Access Compliance Report

Public Rights-of-Way

(Curb Ramps)

Intersection ID: 10019976	Main Street: ARENA_BV	Cross Street: N/A	Location: S
ADA ID: 266BC6F98FEB	Ramp Type: PerpDiag	Initial Pass/Fail: Fail	Overall Compliance: No
			Severity Score: 33.75

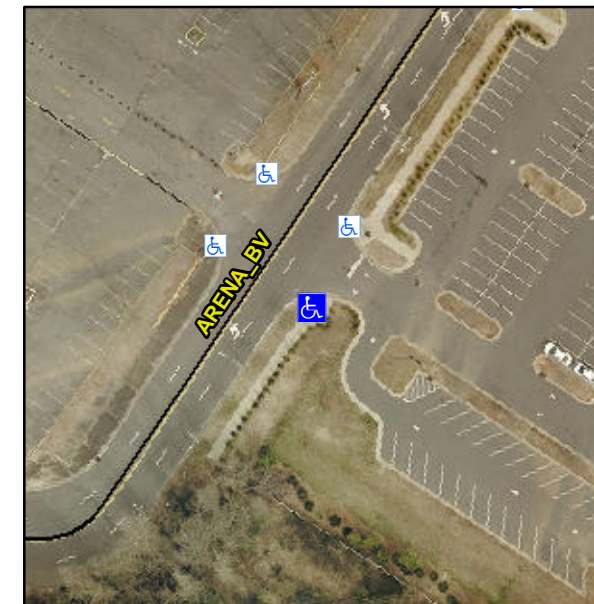
Not Found, R304.5.1, R304.2.2, R304.5.3

Compliance	Description	Data	Compliance	Description	Data
N/A	Ramp Length (in)	94.0	No	Ramp Slope (%)	8.5
No	Ramp Width (in)	43.0	No	Ramp XSlope (%)	5.4
N/A	Flare Type LT	N/A	N/A	Flare Type RT	N/A
N/A	Flare Slope LT (%)	N/A	N/A	Flare Slope RT (%)	N/A
N/A	Flare Traversable LT?	N/A	N/A	Flare Traversable RT?	N/A
N/A	Landing Length (in)	N/A	N/A	DWS Provided?	N/A
N/A	Landing Width (in)	N/A	N/A	DWS Contrast?	N/A
N/A	Landing Slope (%)	N/A	N/A	DWS Length (in)	N/A
N/A	Landing X Slope (%)	N/A	N/A	DWS Full Width?	N/A
N/A	Landing Curb? (Y/N)	N/A	N/A	DWS Offset (in)	N/A
N/A	Shared Landing?	N/A			
N/A	Gutter Ponding?	N/A	N/A	Gutter Slope (%)	N/A
N/A	Gutter Lip Ht (in)	N/A	N/A	Gutter X Slope (%)	N/A
N/A	Painted X Walk1?	No	N/A	Painted X Walk2?	No
	X Walk 1 Direction	To NE		X Walk 2 Direction	To NW
N/A	X Walk 1 Width (in)	N/A	N/A	X Walk 2 Width (in)	N/A
	X Walk 1 Slope (%)	4.1		X Walk 2 Slope (%)	3.5
	X Walk 1 X Slope (%)	3.1		X Walk 2 X Slope (%)	5.5

Remove & Replace Curb Ramp With Two New Directional Ramps or Equivalent.
